Our Ref: B3031

Re: Minto Resource Recovery Facility (SSD-5339)
3 November 2021 - Request for additional information

We refer to the subject request for additional information and provide below our response to the issues raised. Issues raised are shown in green with responses provided.

PROJECT NO. P1203464	PLANSET NO. PS02	RELEASE NO. R25	DRAWING NO. PS02-DZ10	REVISION G
-------------------------	---------------------	--------------------	--------------------------	---------------

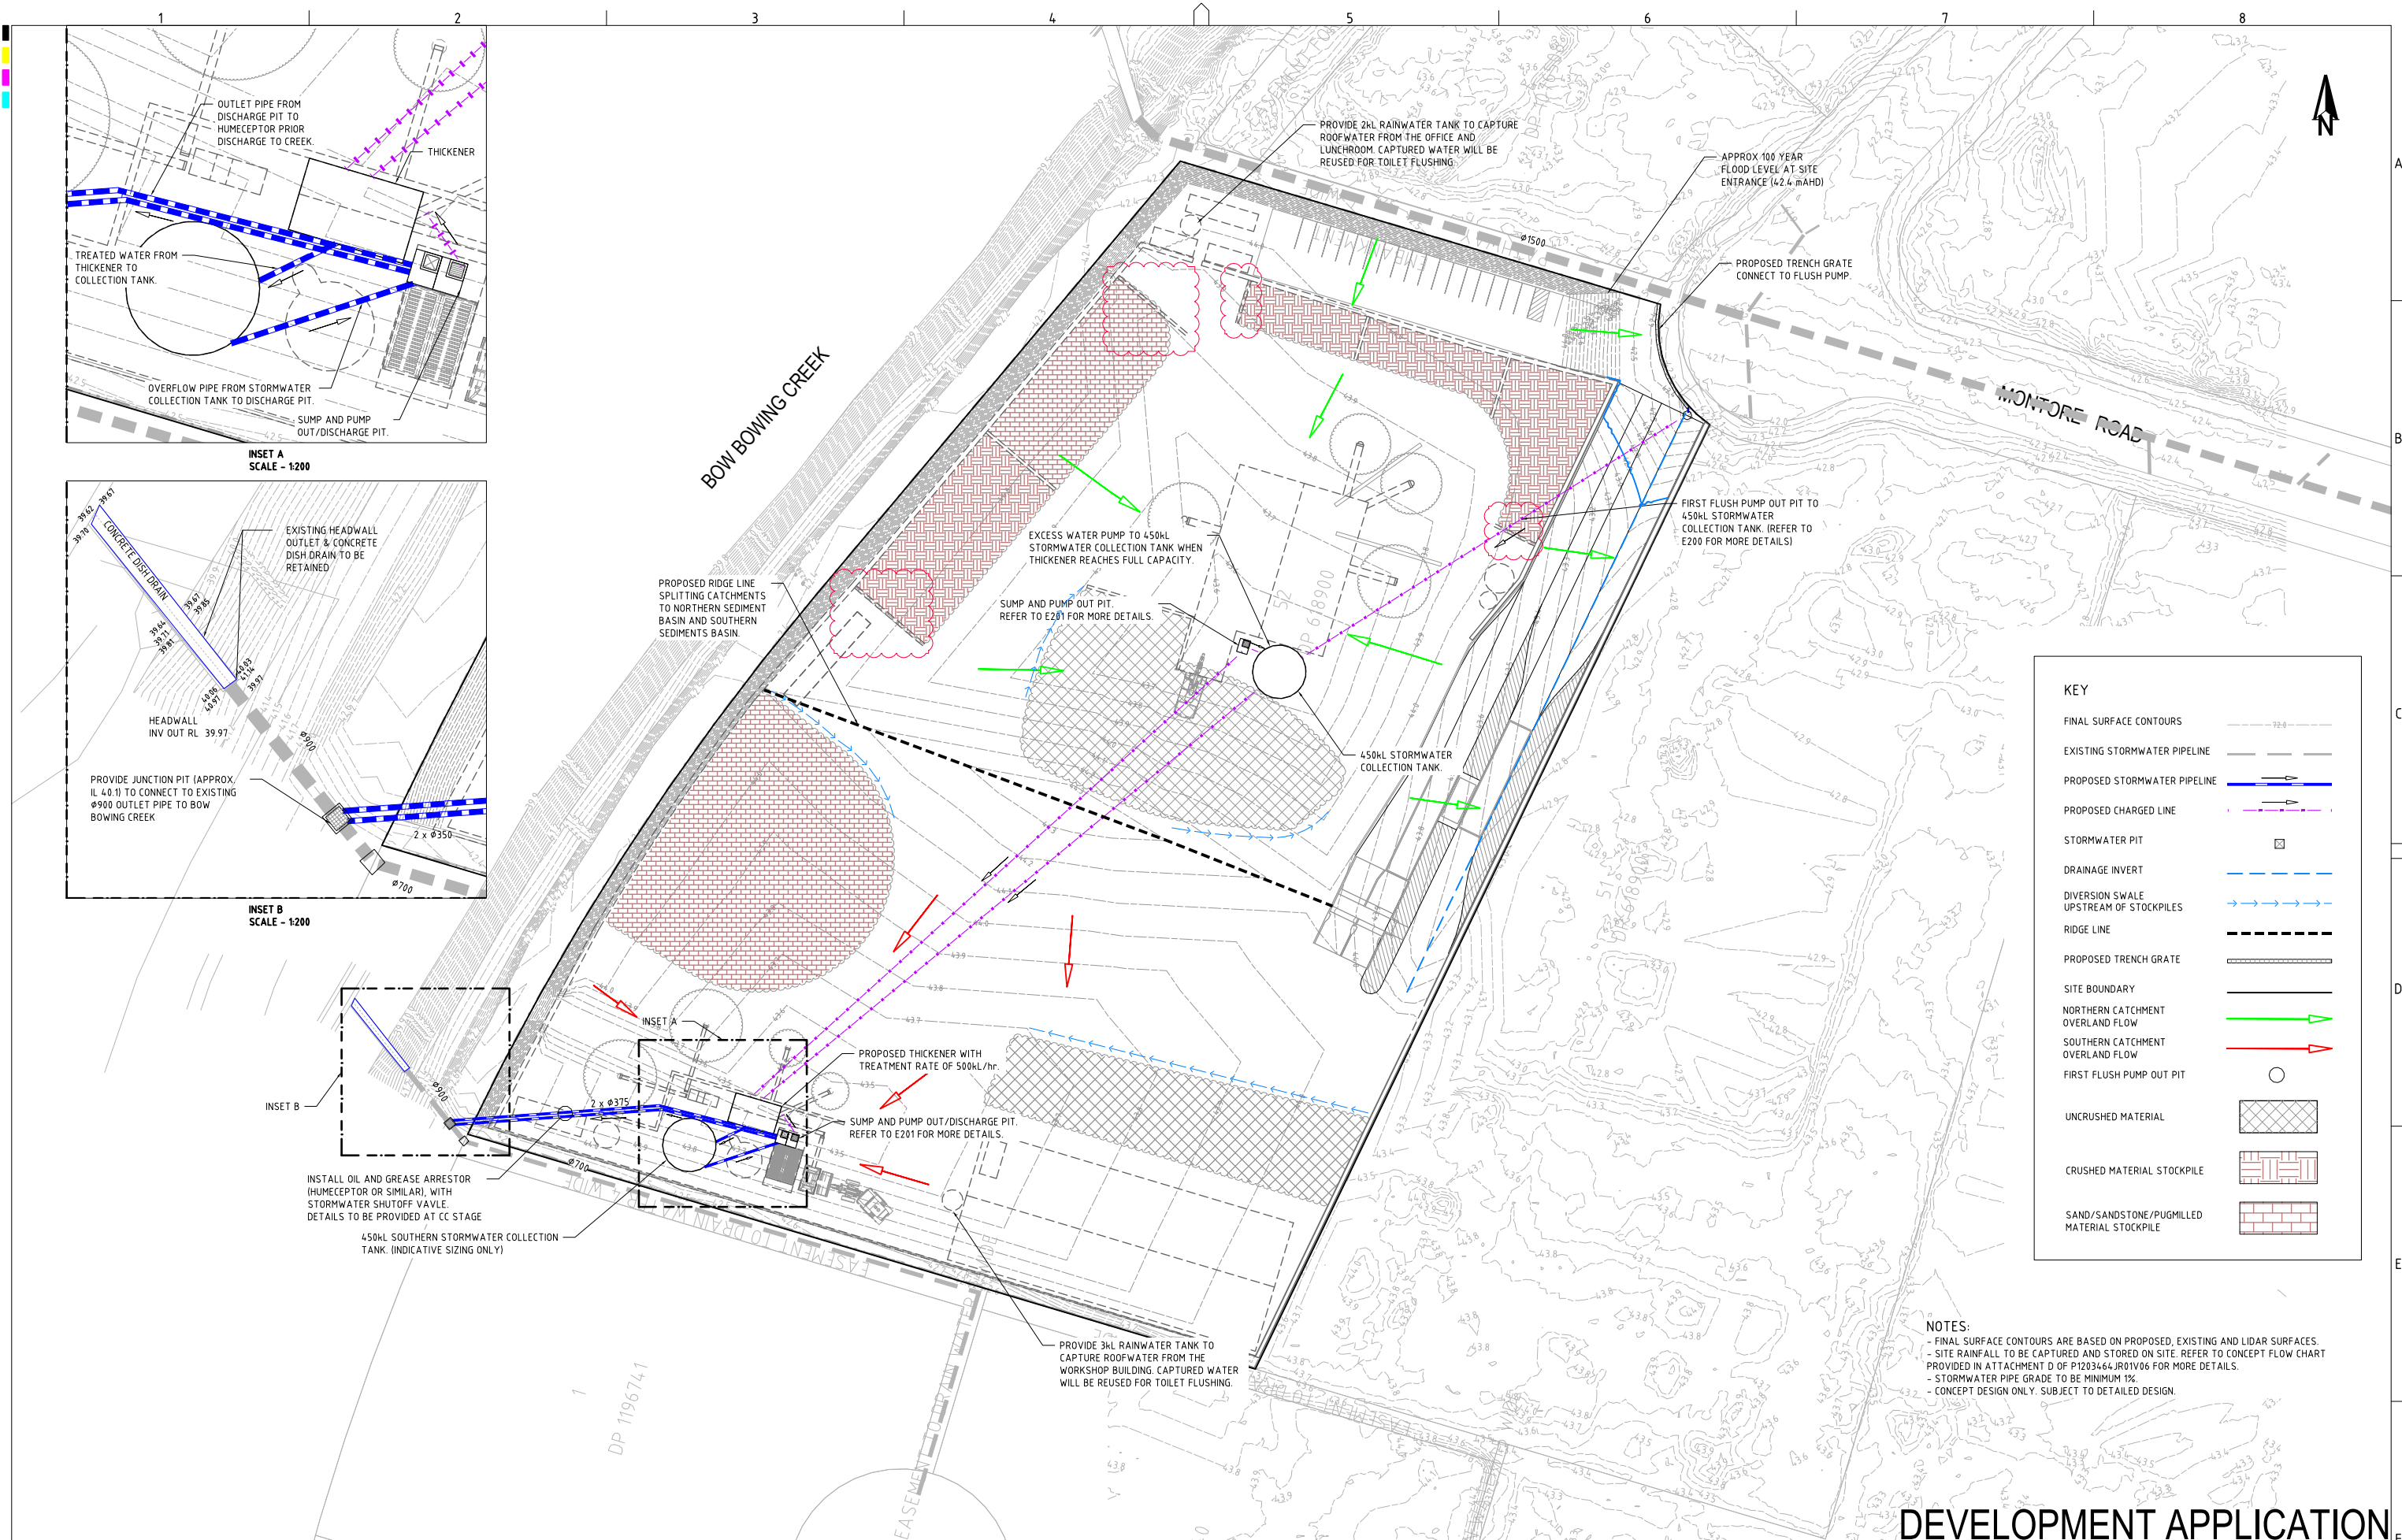
Comment

The nature of the facility is such that stockpile size and, hence, location is dynamic with the general layout of the Site at capacity shown on the plans accompanying the RTS. Plan PS02-DZ10, Revision G shows the stockpile locations, unloading and loading areas in general terms which allows for the dynamic nature of the facility.
